Wellington City Proposed District Plan

Hearing Stream 3 – Viewshafts

Section 42A of the Resource Management Act 1991

SUBJECT: **Wellington City Proposed District Plan**
– Viewshafts Section 42A Report

Figure 34: Showing the amended right margin and extent of PDP-VS15 to align with SCHED5.

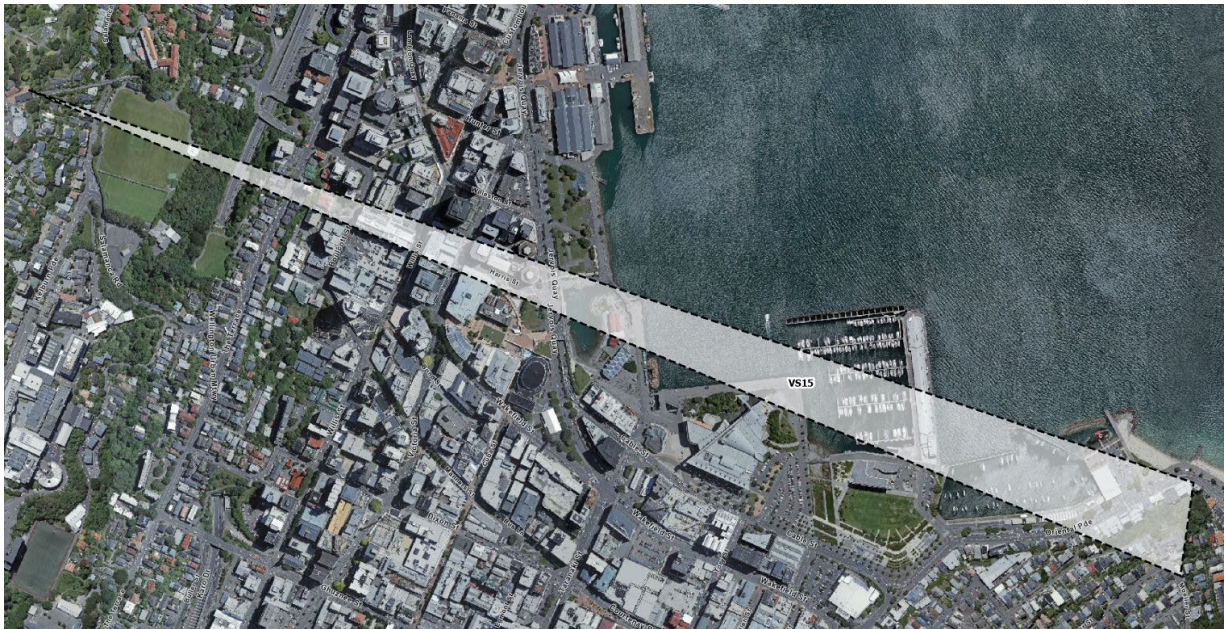
- xv. Correct PDP-VS15 to narrow the right margin to intersect with the south-west corner of 2 Oriental Terrace (as per the description in SCHED5), see Figure 34.

Figure 20: Full view of the proposed amendment to PDP Viewshaft 8.

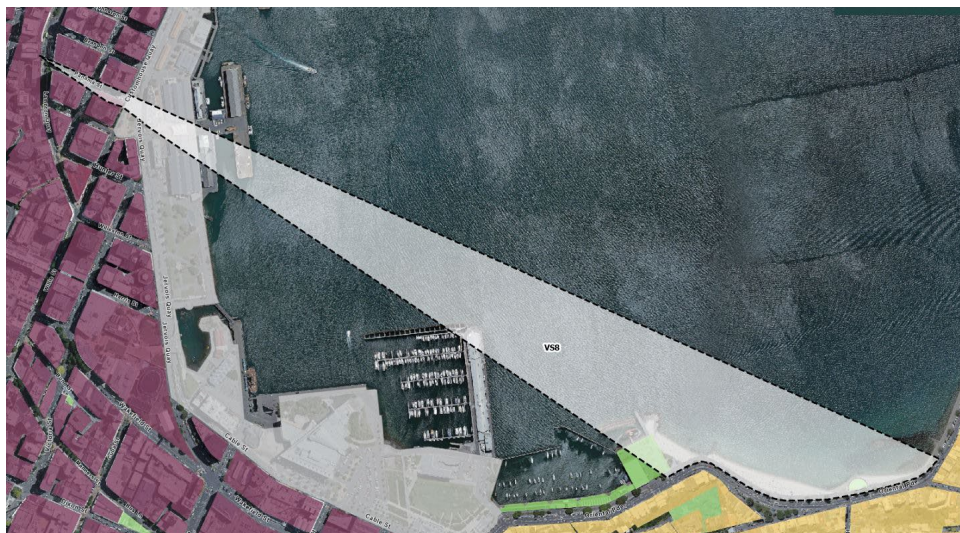
HS3-VIEW-Rec25: That Viewshaft 8 in SCHED5 – Viewshafts be amended as per Figures 19 and 20, including amending the end point to align with the frame shown in the correlating image in SCHED5 for PDP-VS8, to extend to the northern road edge of Oriental Parade:
